Panel Report

Central Goldfields Planning Scheme Amendment C31cgol Dunolly and Carisbrook Flood Studies

23 December 2020

Figure 2 Map 13 as exhibited showing the LSIO and FO for (most of) Carisbrook

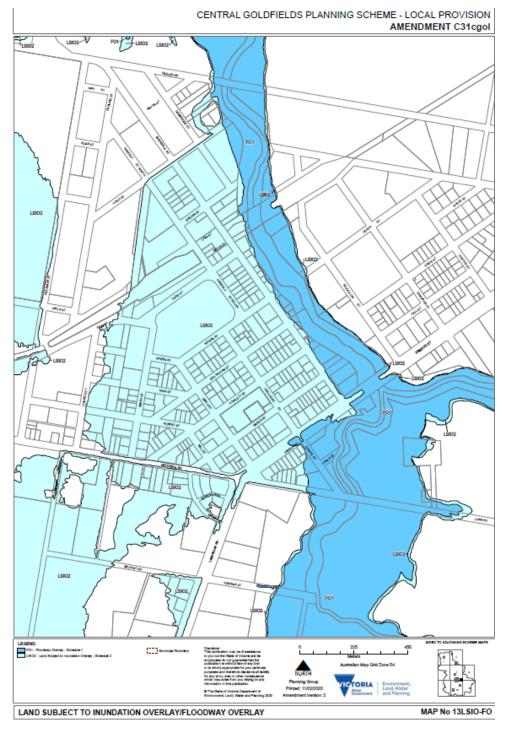
Figure 2 shows the extent of the LSIO and FO as proposed for most of the township area of Carisbrook. While not showing all of the township, the map does cover the properties of submitters 4 and 6 and illustrates the breadth of overlay boundaries of interest to submitter 11.

Figure 3 Proposed replacement map for Dunolly

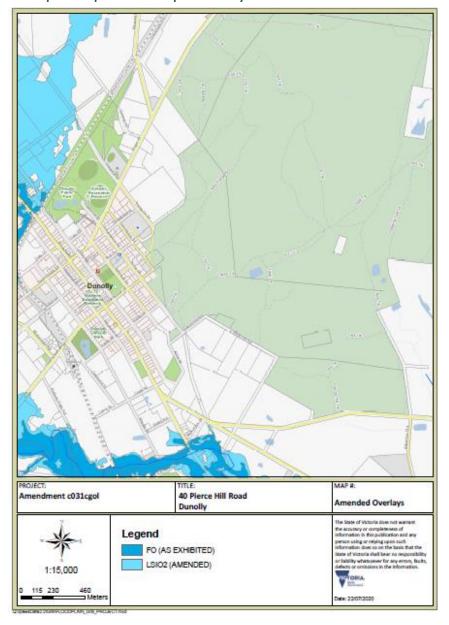
Change number one sought by Council sought to replace the exhibited LSIO/FO at map 5 with a map revised to accommodate the recent flood mitigation works have that reduced flood risk. No revised map was provided to demonstrate this agreed change to the area of Pierce Hill Road, Dunolly.

Council has requested that the Panel recommend the adoption of the variation. This approach was flagged and accepted by Council at its meeting on 25 August 2020 where it considered and adopted the response to submissions. At that meeting, an attachment to the report showed a map to demonstrate the change. That map is reproduced (Figure 3). The Panel notes the map is the same as presented at the Hearing as Figure 17 in Council's Part B submission.

The Panel accepts this approach. It will allow Council time to have the relevant map prepared and included in the Amendment for adoption. The Panel recommends adoption of an LSIO2 map in the form proposed by Council.

Figure 4 Mr Rinaldi's alternative overlay map for 33 McCallum Street, Carisbrook

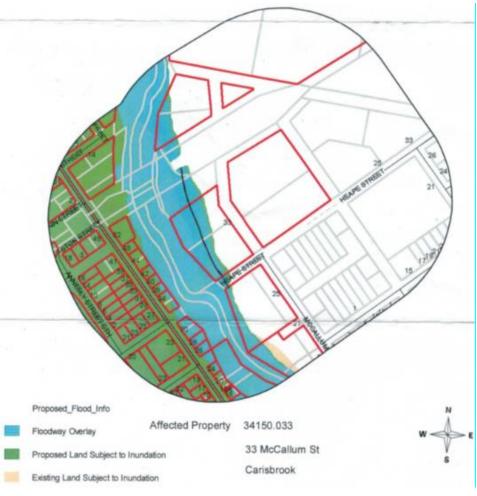
Submitter 4 lodged an alternative plan for the FO proposed for the land at 33 McCallum Street to reduce the extent of the overlay on his assessment of the spread of flood waters.

Mr Rinaldi's submission included a map, reproduced (Figure 4) to show how he believed the overlays should be applied. The black line in the map is his alternative border.

In response, Council noted¹ the subject site is partly constrained by the LSIO and advised the Panel it "relied on the recommendations of the Flood Management Plan and post submission comments from the NCCMA, and is of the view that the proposed overlays be adopted as exhibited for this land"

On the basis of the material available to it, the Panel accepts the Council submission and recommends no change to the overlay mapping for 33 McCallum Street.

Figure 9 9 Bucknall Street in a 1:100 flood event

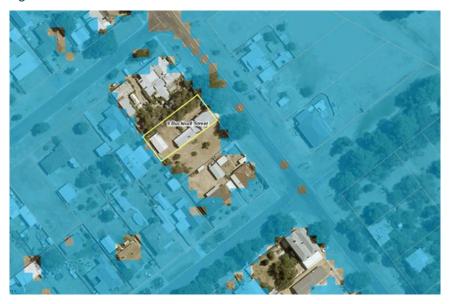
Submitter 6 opposed the Amendment. While opposing the LSIO on the property at 9 Bucknall Street, the core submission was to "get the mitigation work done first and then amend the planning maps".

Mr Hodgkins' property is captured by that approach. This is demonstrated in Figure 9 which is a Council and NCCMA image of the 1 per cent AEP flood extent on the subject site.

The Panel accepts the approach to the island sites. The conclusion is that no change needs to be made to the mapping for the subject site at 9 Bucknall Street.
